CITY OF SAN ANTONIO RECEPOADP APPLICATION

Re: The Heights of Westcreek (Amending)

POADP # 484-A

Re: The Heights of Westcreek

M:\4492\10\DESIGN\CIVIL\POADP.DWG (DATE: APR. 25,2000)

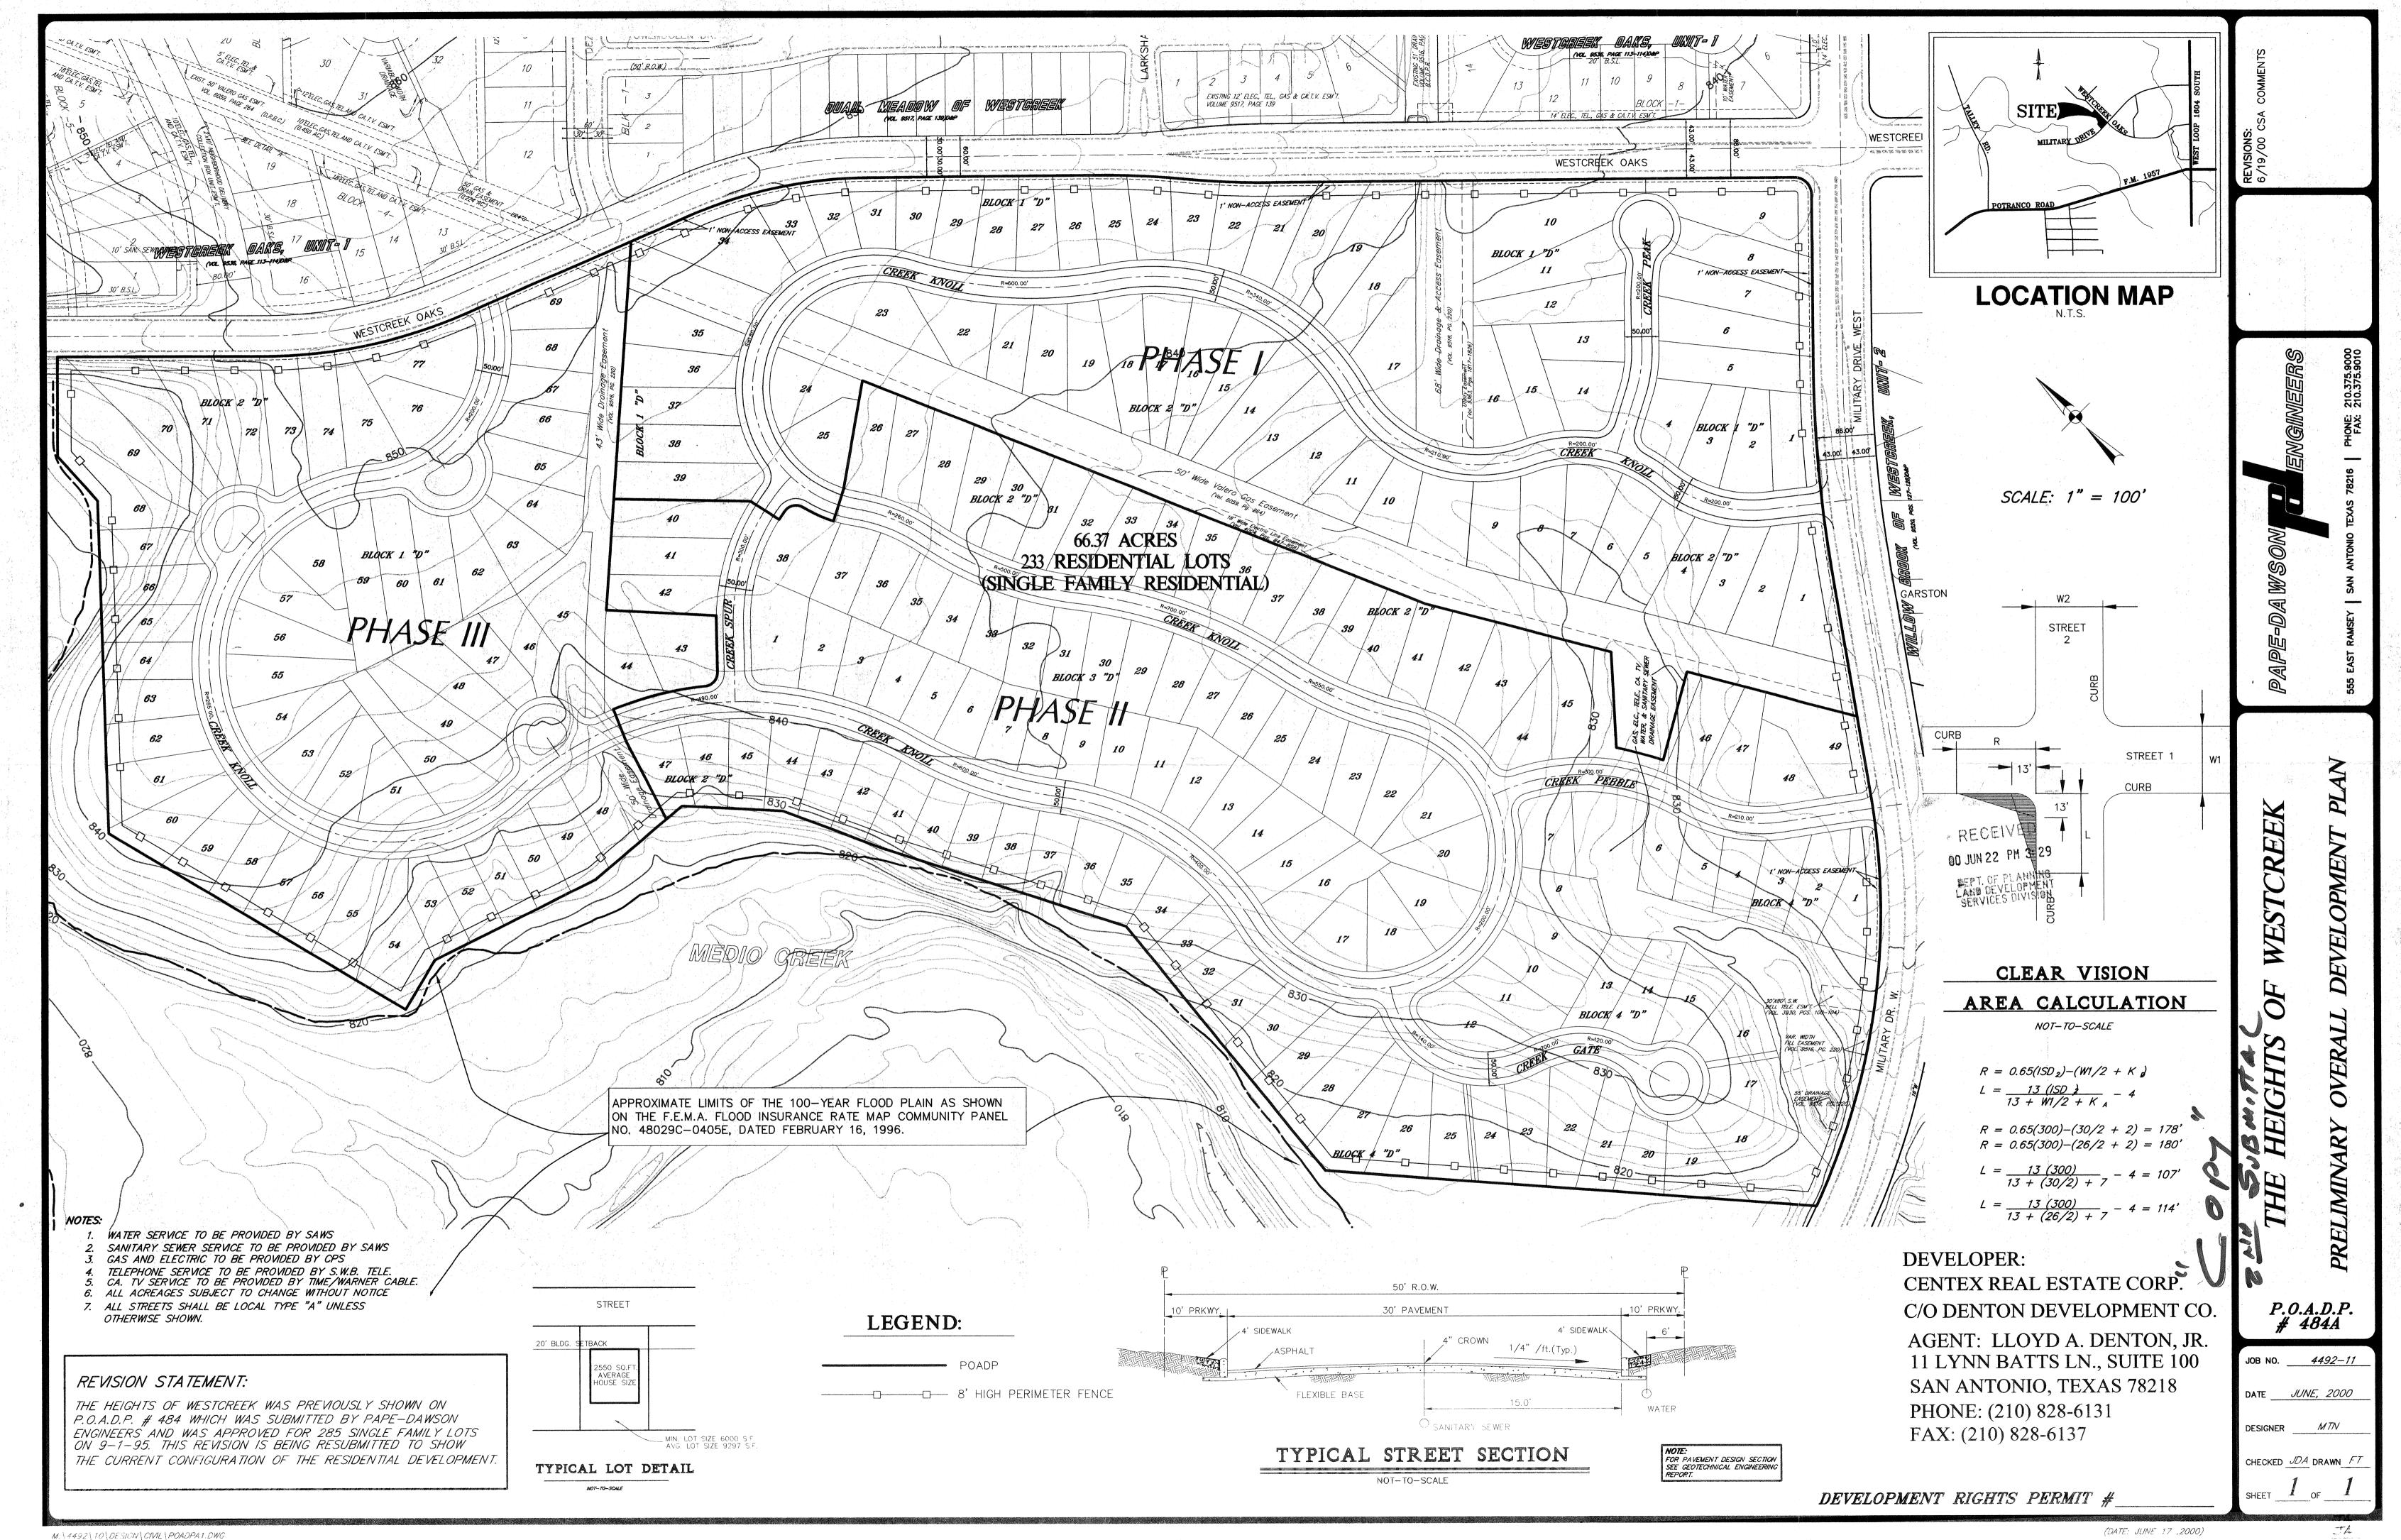
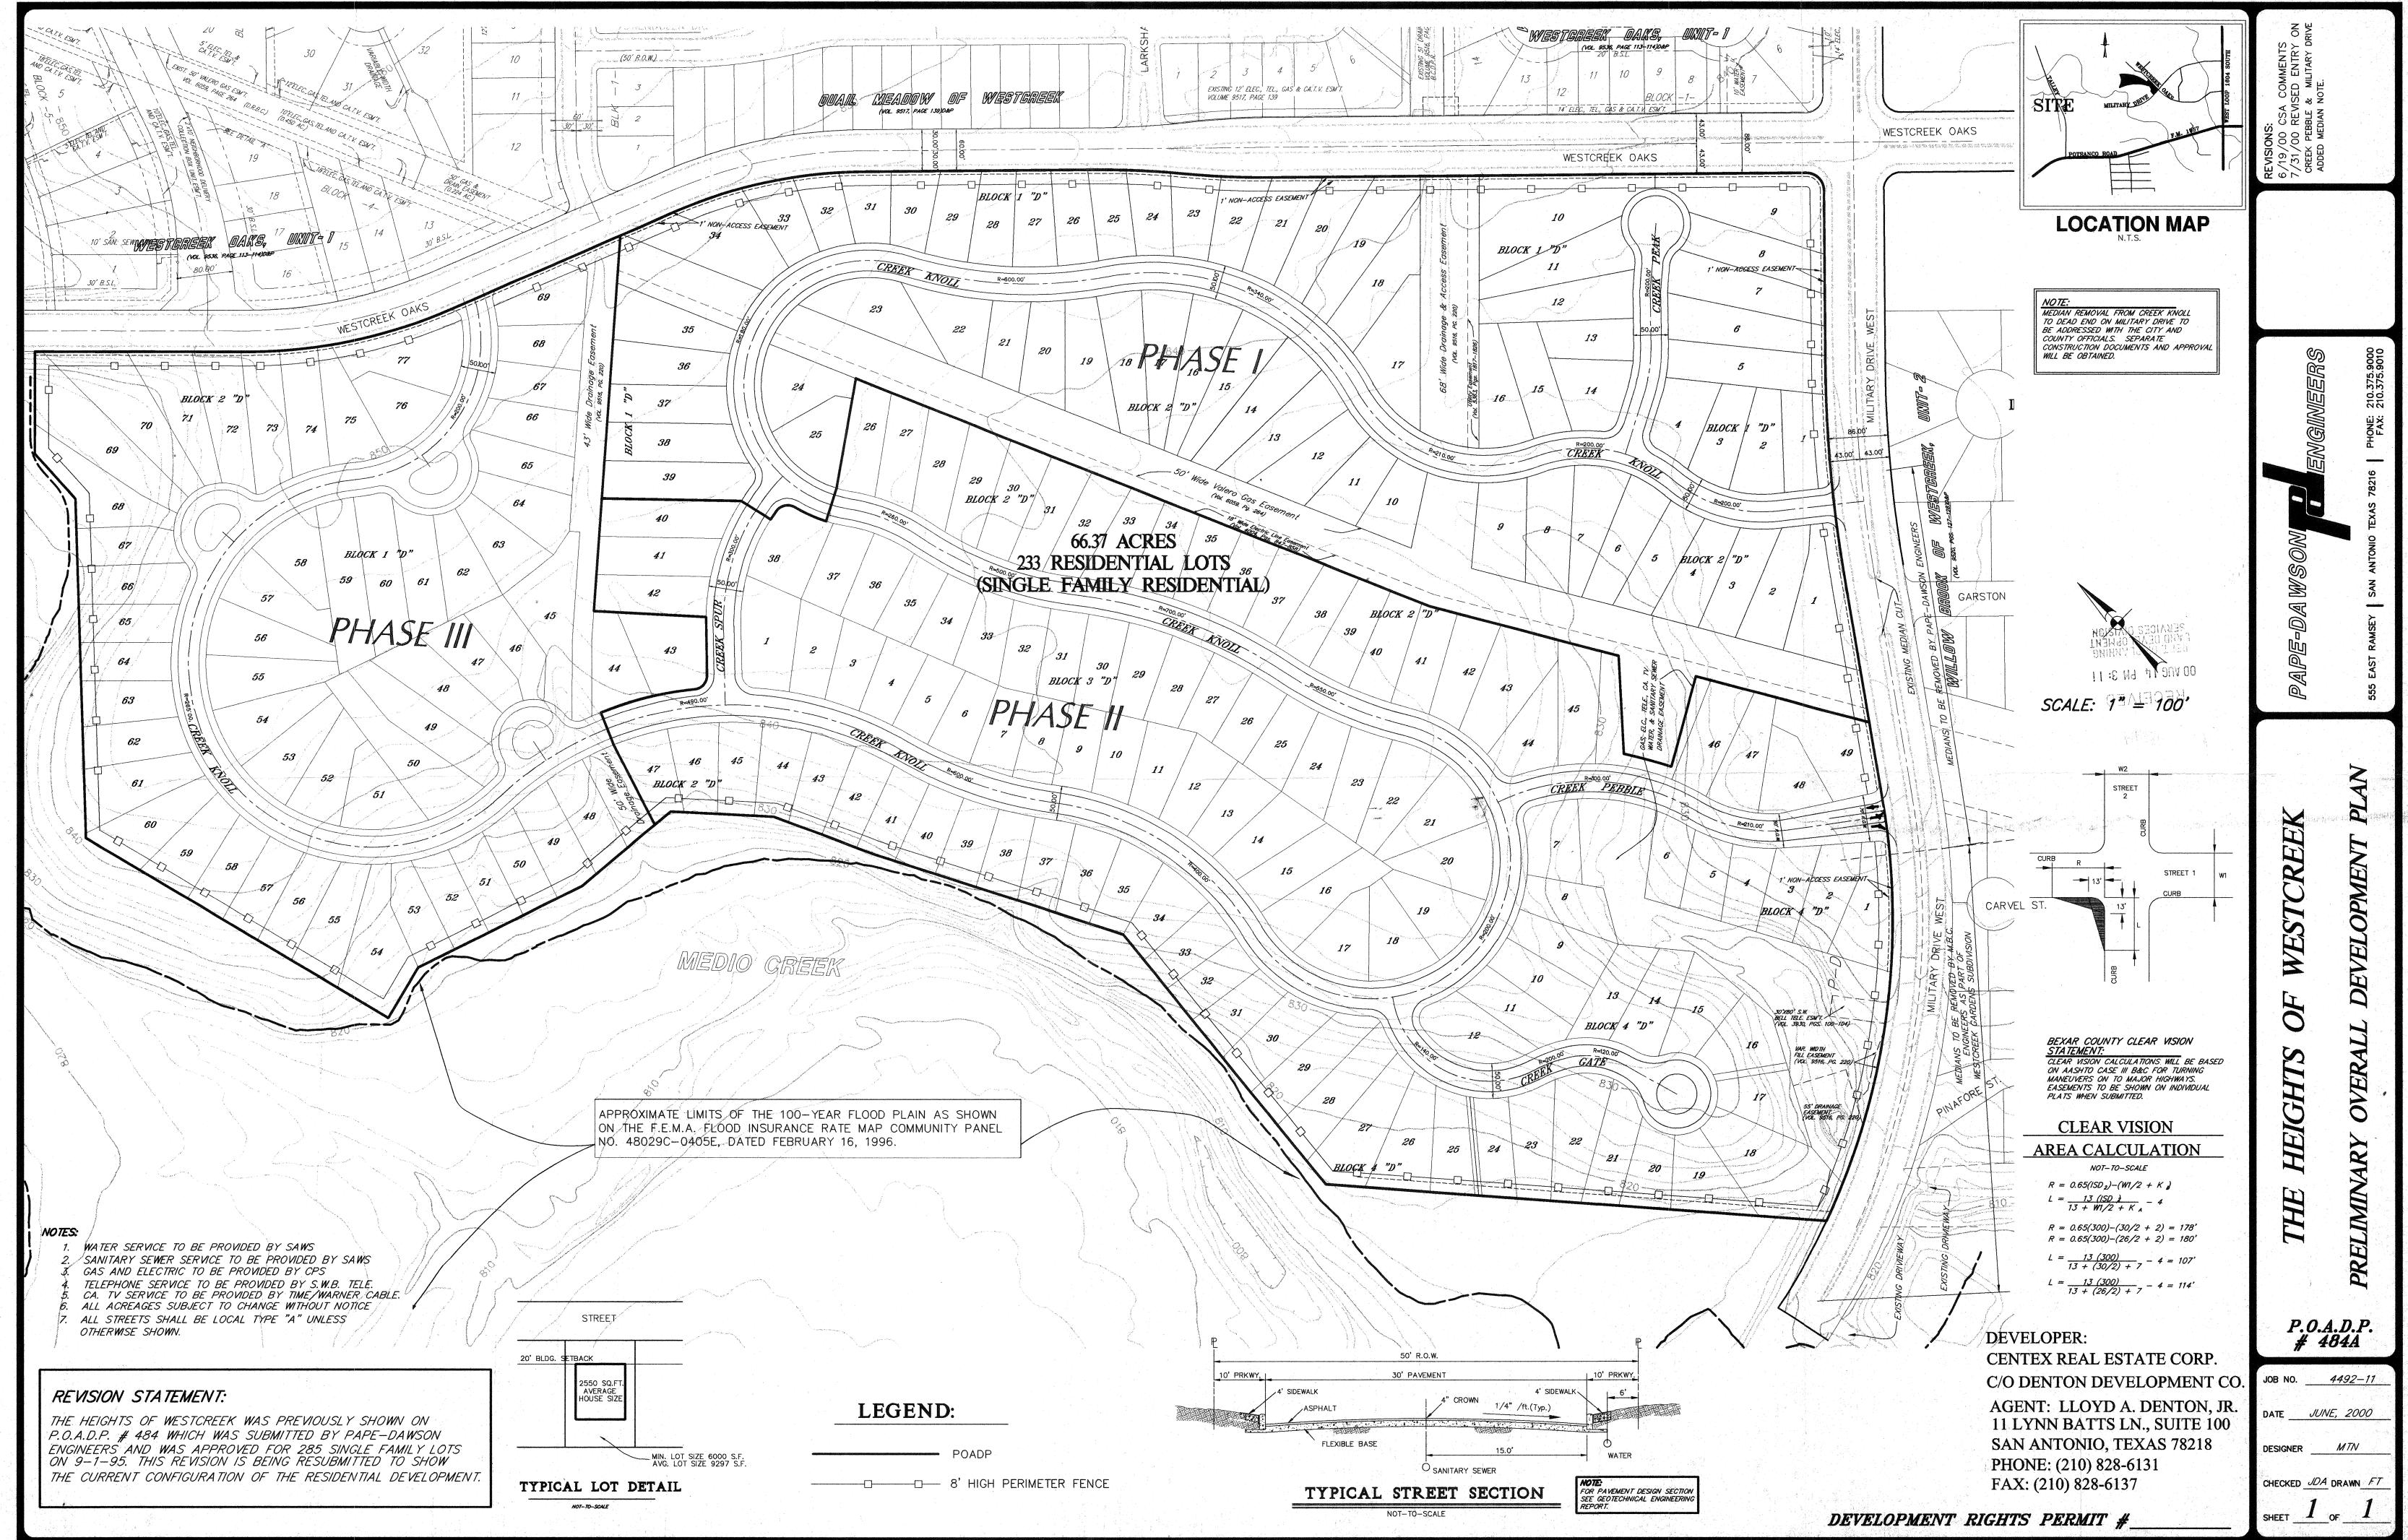
- 1.) The Public Works Department:
- (a) Median opening will not be allowed at Military Drive West at Creek Knoll.
- (b) Creek Pebble to be widen from proposed 50' R.O.W. to a min. of 70' R.O.W. to accommodate left and right turns onto Military Drive West.
- 2.) An approved TIA will be required before the POADP can be accepted.

| SEE GENERAL1.) Sec. 35-2075 Information Required (e) Existing and proposed circulation system of collector, arterial, and local type B street (clearly identified), and their relationship to any adjacent major thoroughfares; and any proposed alternative pedestrian circulation system. Were not clearly identified. All ARE TYPE "A" LOCAL (h) Existing adjacent or perimeter streets (including right-of way widths), intersection, and |
| DONE (i) The one hundred-year flood was identified but was not labeled. 2EEIC NAME AS ADDED. 2.) Proposed street "A" on phase III should align with the existing entrance to Westcreeck |
| Oaks, U-1, to form a proper intersection. > (AS PER WHO?) SECTION 35-4104 STATES 125' & /E Jobs DONE -3.) Please provide the Legend with the utility purveyors. ARE "Proper Intersections" |
| DISK -> 4.) The digital file was missing from submittal. WE ARE Approximately 200± Feet from the, NEAREST |
| TIA Submitter + 5.) A TIA will be required. TO CSA - See Attacheo Signed work sheet To CSA - See Attacheo Signed work sheet |

A SEPERATE PLAN WILL be Submitted to the City for the median REMOVAL along Military Drive. P.D.A.D. P to be approved SEPERATLY. FERNANDO Deleon will have plans delivered to him the WEEK of the 14th.
